#### Project: IEEE P802.15 Working Group for Wireless Personal Area Networks (WPANs)

**Submission Title:** [Resolution to CID 408 of LB 87]

Re: [Proposed resolution to CID 408 of LB 87]

# **Quantifying Results**

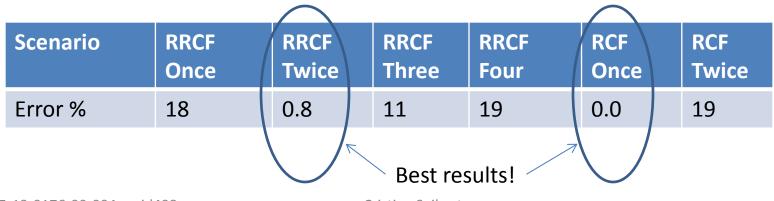
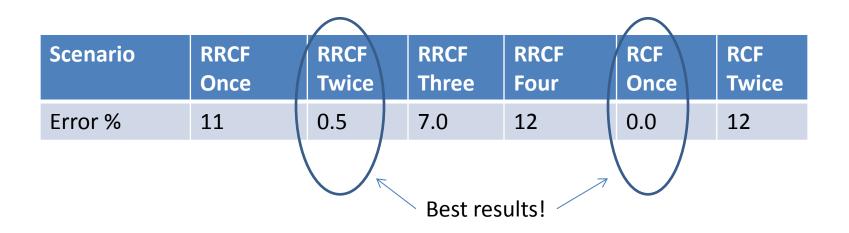
- Performance sensitive to filter combination types.
- A Raised Cosine Filter or two cascaded Root Raised Cosine Filter implementations essentially exhibit Nyquist properties.
- Other filter combinations lead to ISI, e.g.:
  - A single Root Raised Cosine Filter
  - Two Raised Cosine Filters
  - A Raised Cosine Filter cascaded with a Root Raised Cosine Filter
- As shown previously, some filtering at RX required, e.g. for noise limiting purposes.
- Thus, two cascaded Root Raised Cosine Filters should be used, one at the TX and another at RX respectively.

- Change paragraph in 20.2.4.2 to:
  - "Pulse shaping shall be applied at the transmitter using a filter equivalent to the Root Raised Cosine filter with a roll-off factor of 0.5. The parameters of the filter shall be as needed to meet regulatory requirements in the band of operation. It is recommended that the receiver also use a filter equivalent to the Root Raise Cosine filter with a roll-off factor of 0.5".
